**CORRIDOR REVIEW COMMITTEE
 STAFF REPORT AND RECOMMENDATION**
 Prepared for January 8, 2026 Meeting

Application HP2025-0081

Address: 555 W. King Street

Project description: To construct a connected accessory structure to the west of the existing building and associated changes to the site and landscaping along the King Street Entry Corridor.

**BLDG
 ELEVATIONS**

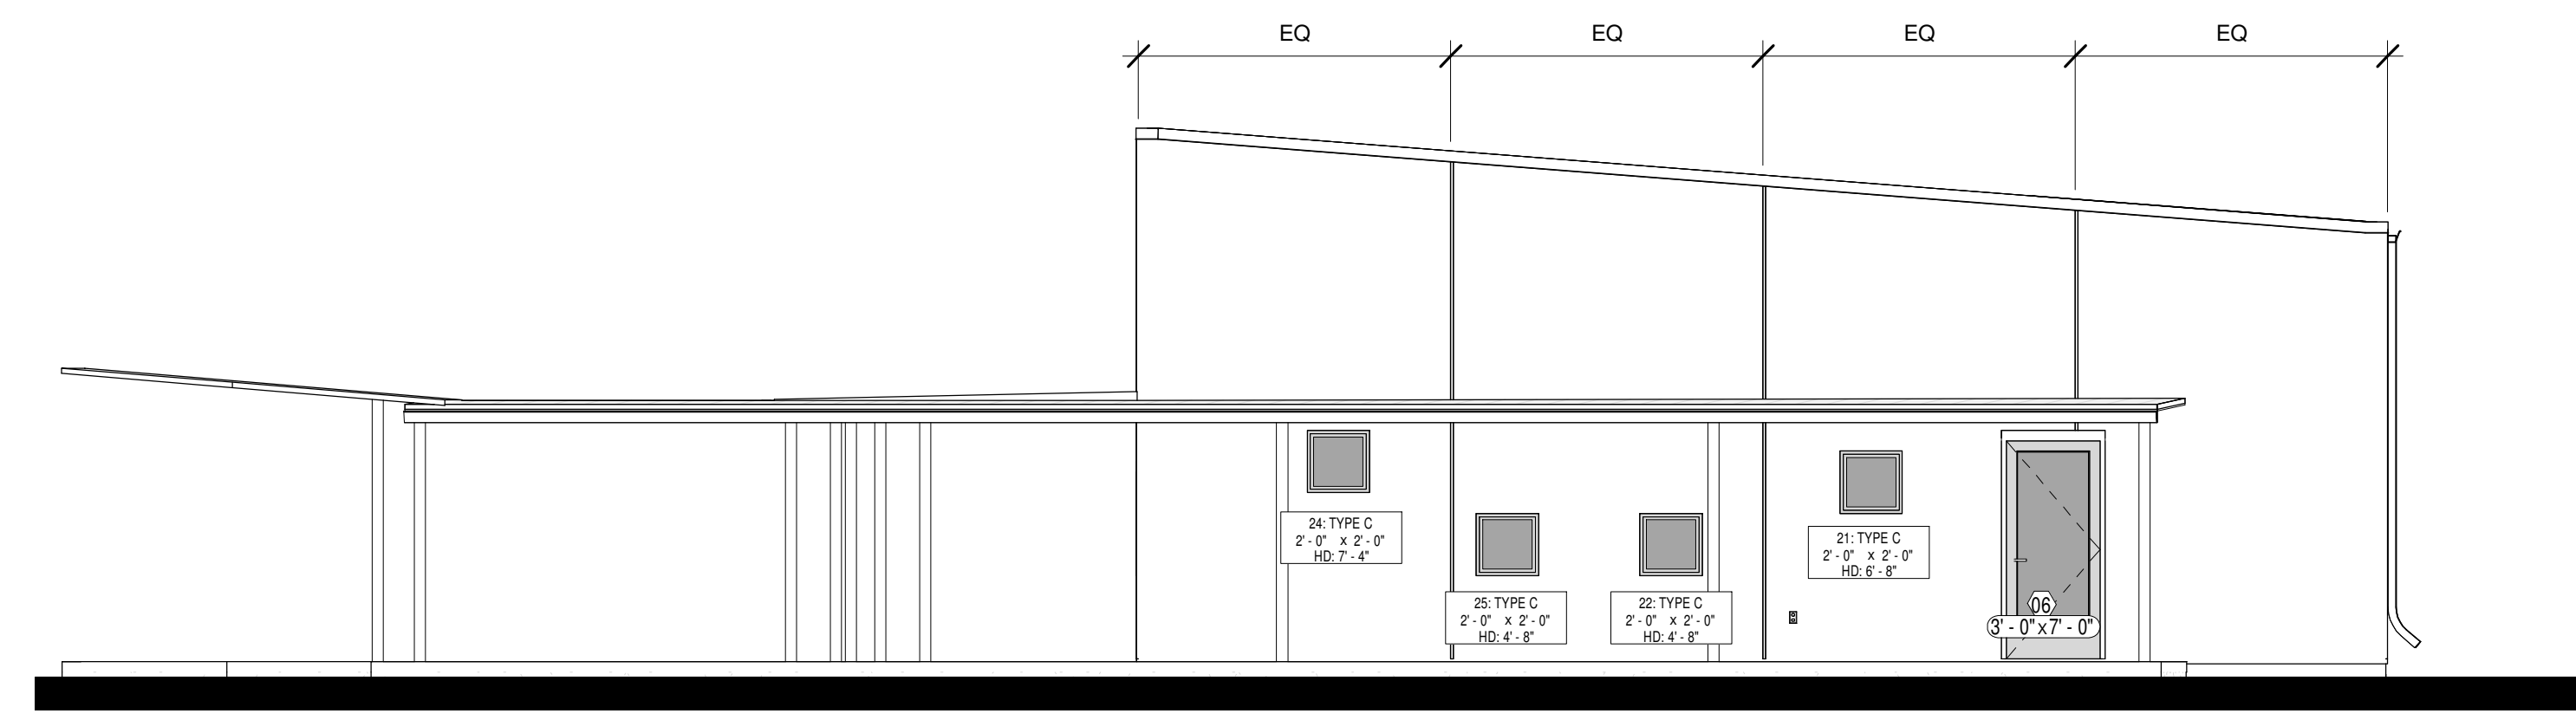
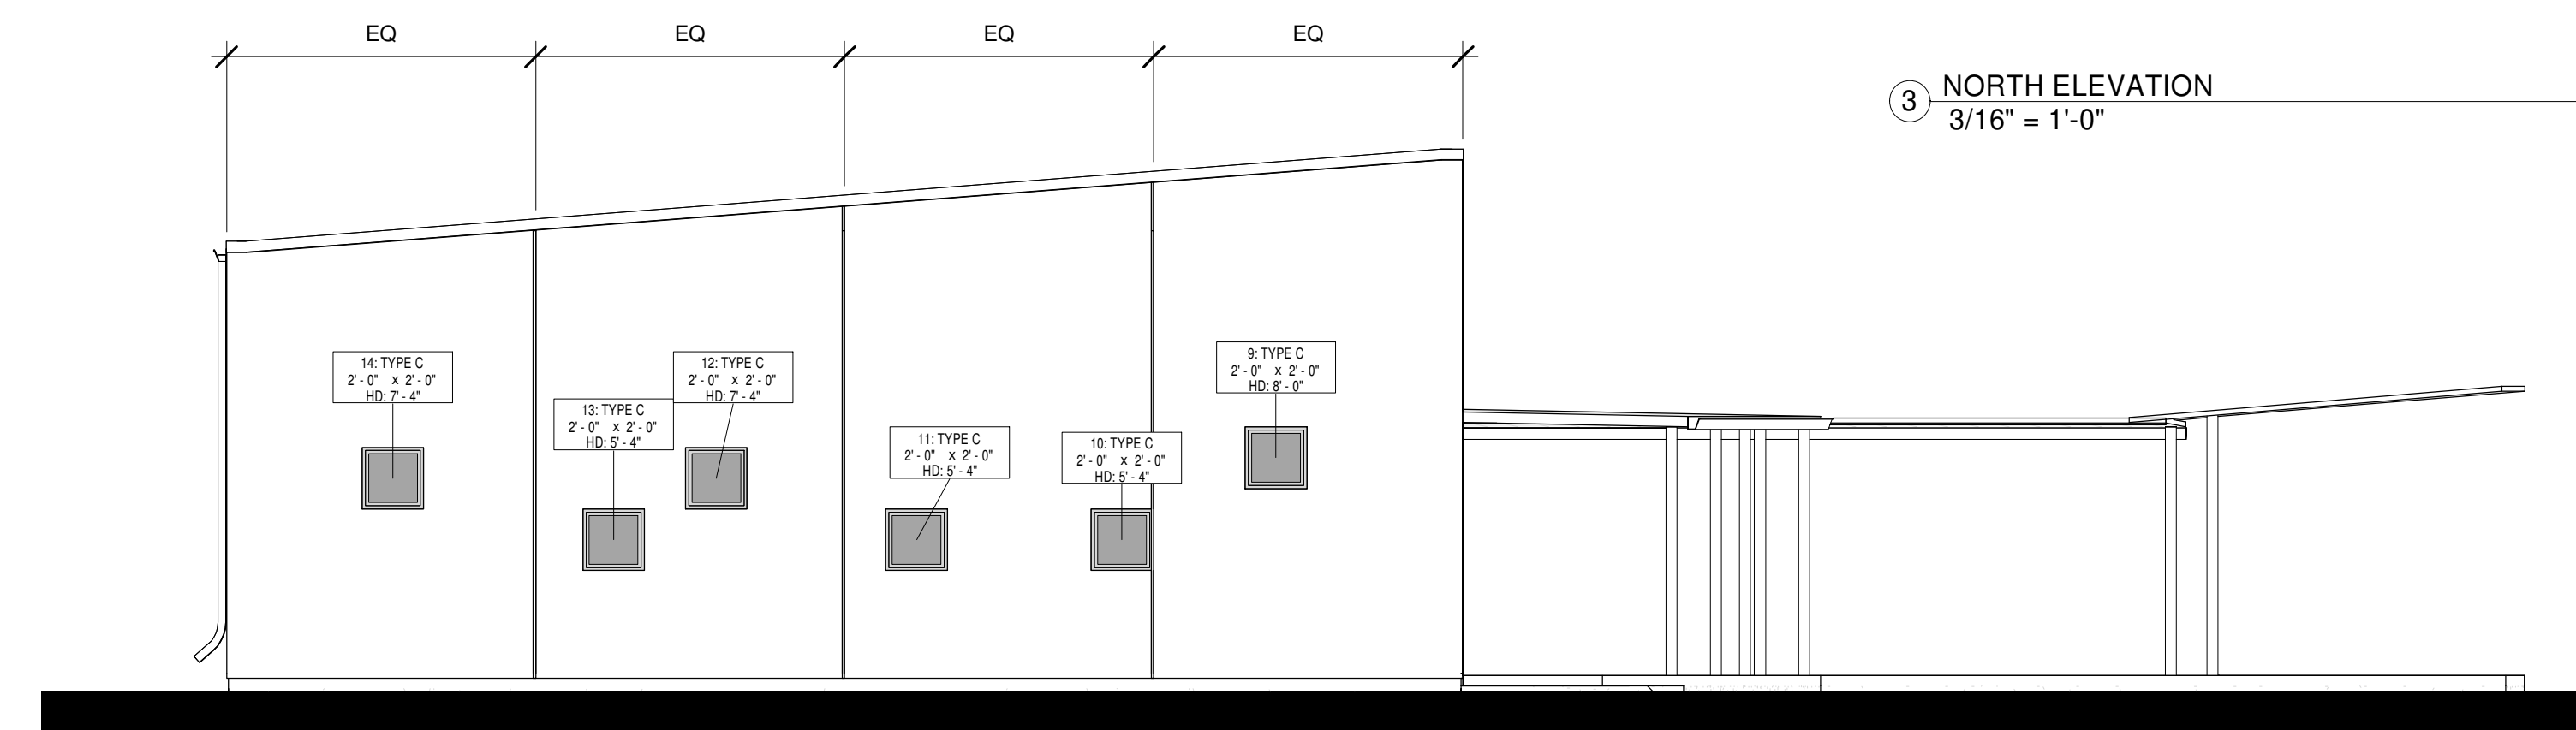
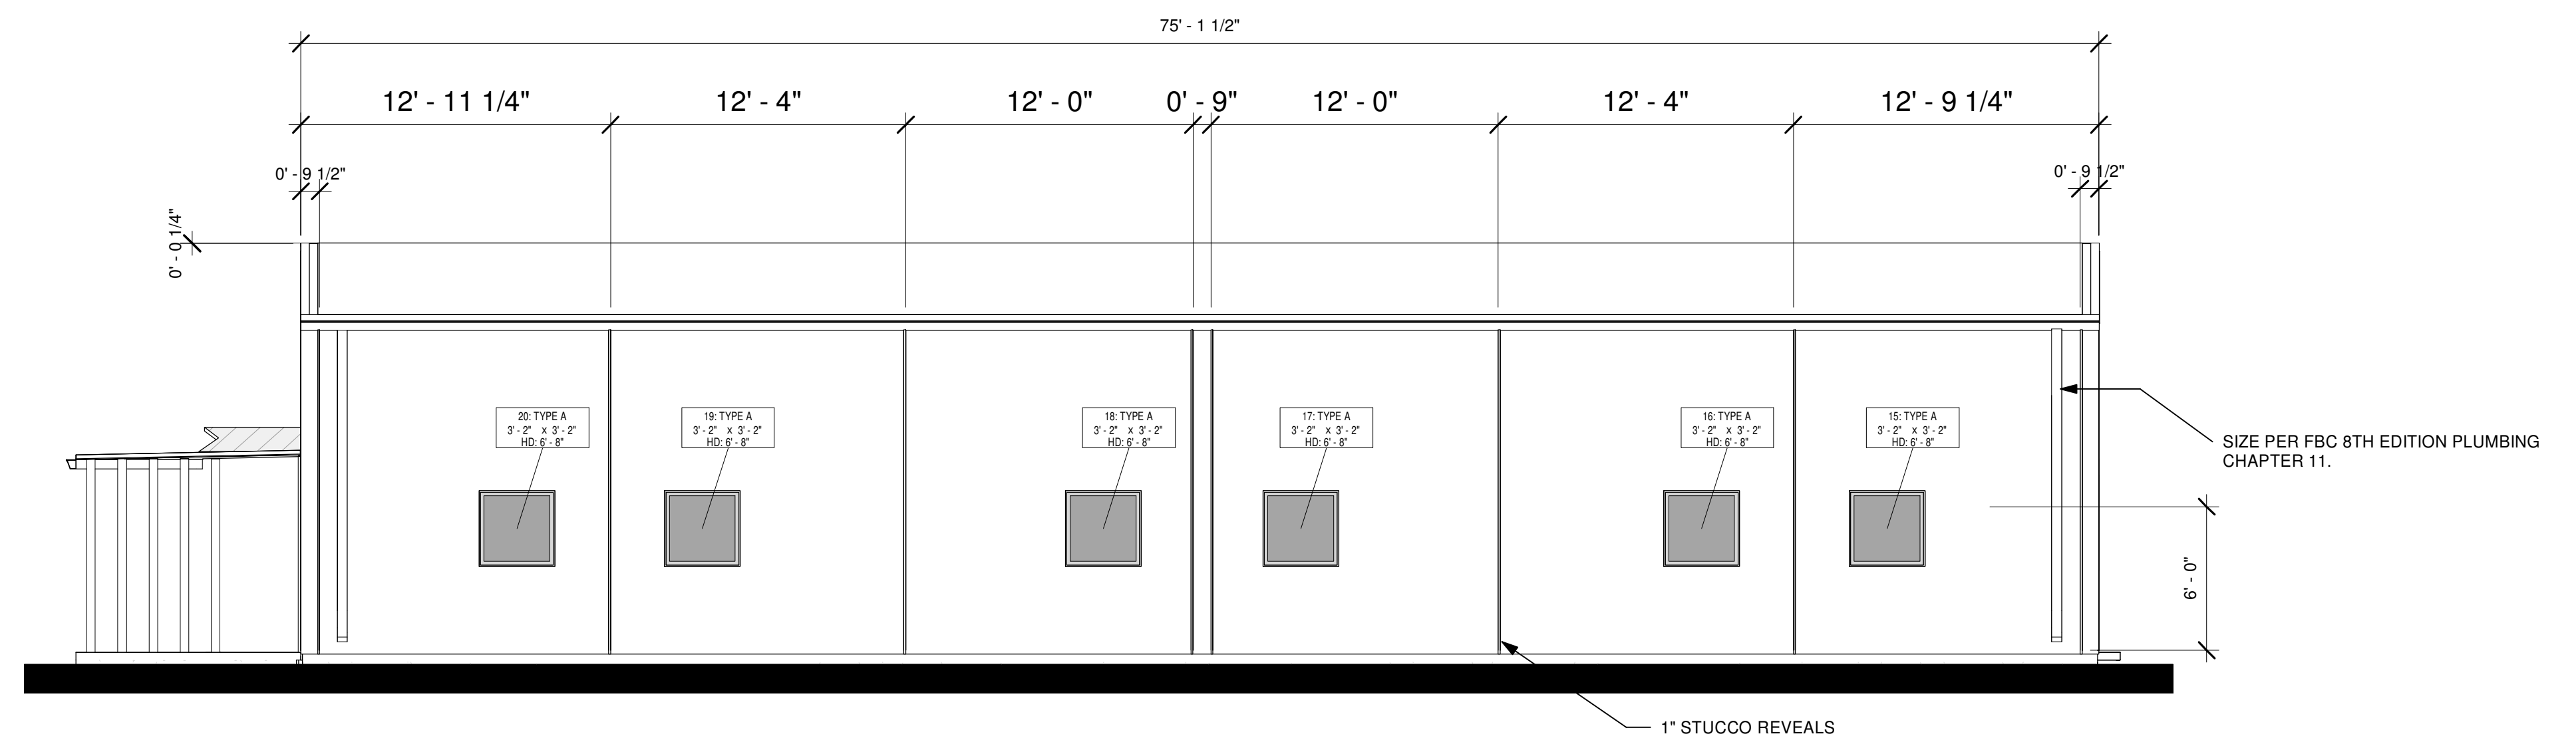
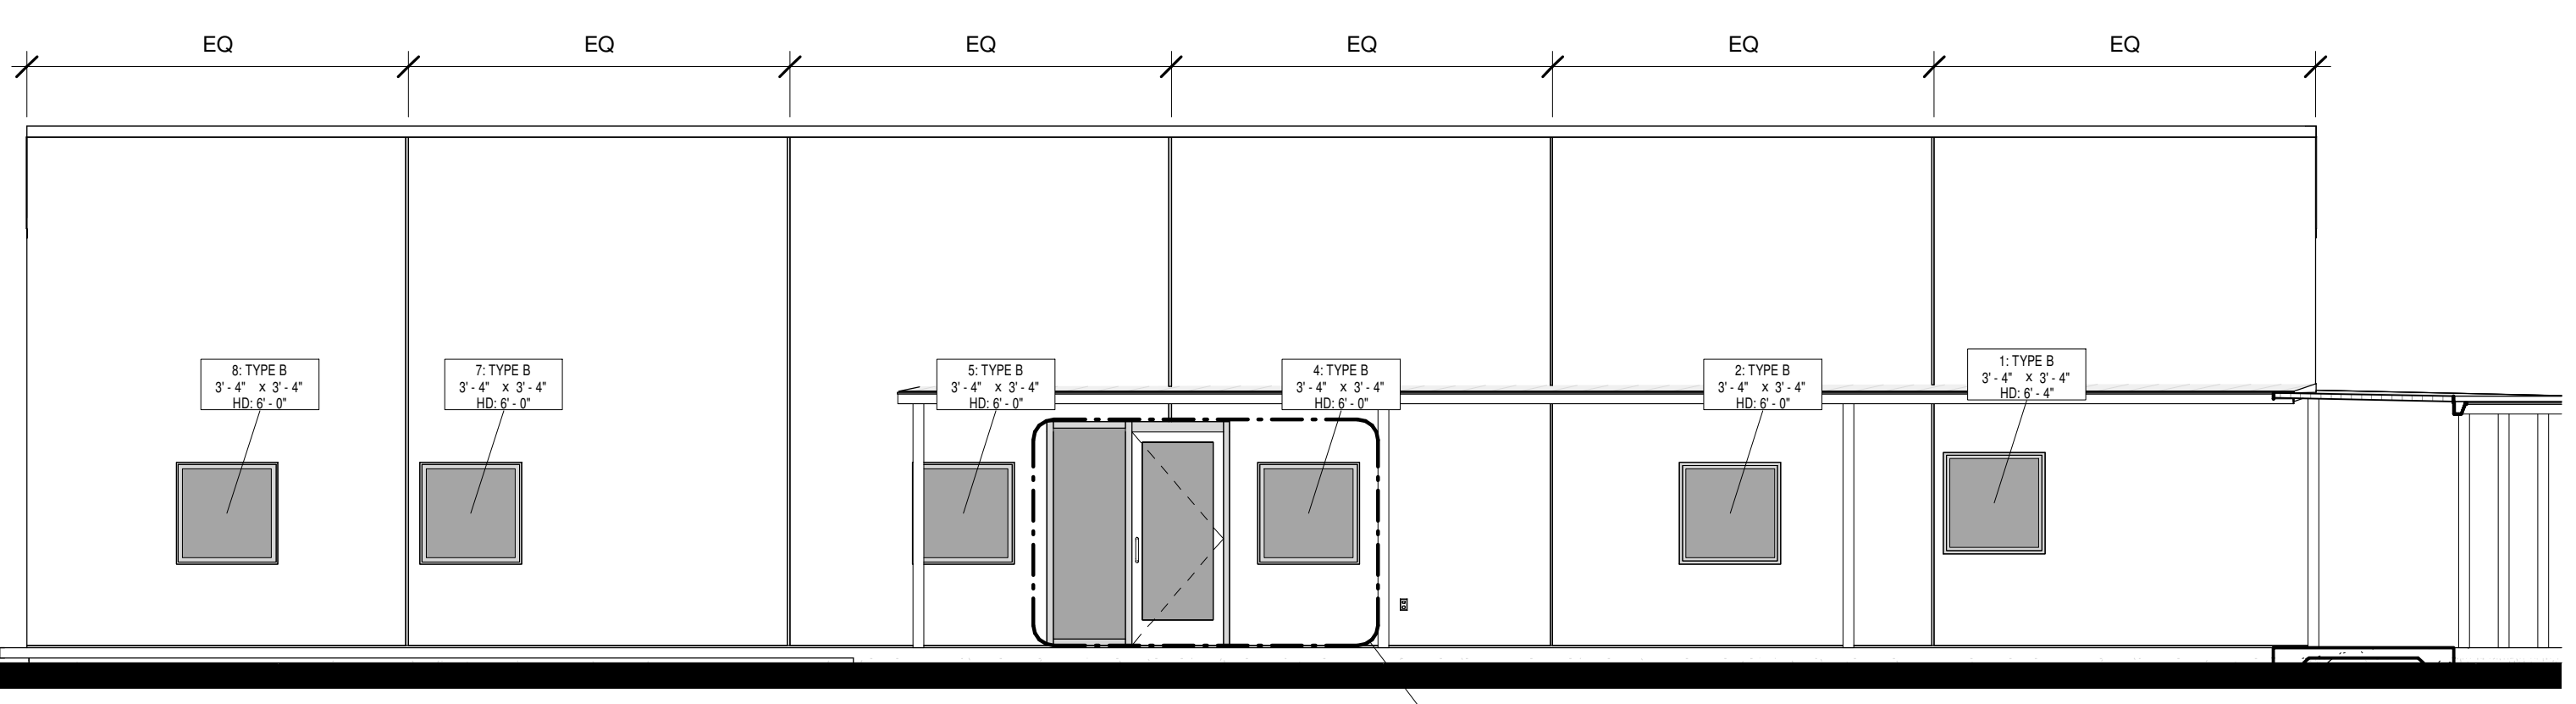
3. The proposed addition is consistent with the existing architecture of the building, featuring a gently sloped shed roof with roof which transitions from a maximum height of 17' down to 14'. Exterior finishes, windows and door systems are also consistent with the existing structure and are not prohibited within the corridor. Originally submitted site plans show the addition angled slightly to the west; however, this has been modified in late site plans to be consistent with Entry Corridor requirements. Colors are not regulated along W. King Street.
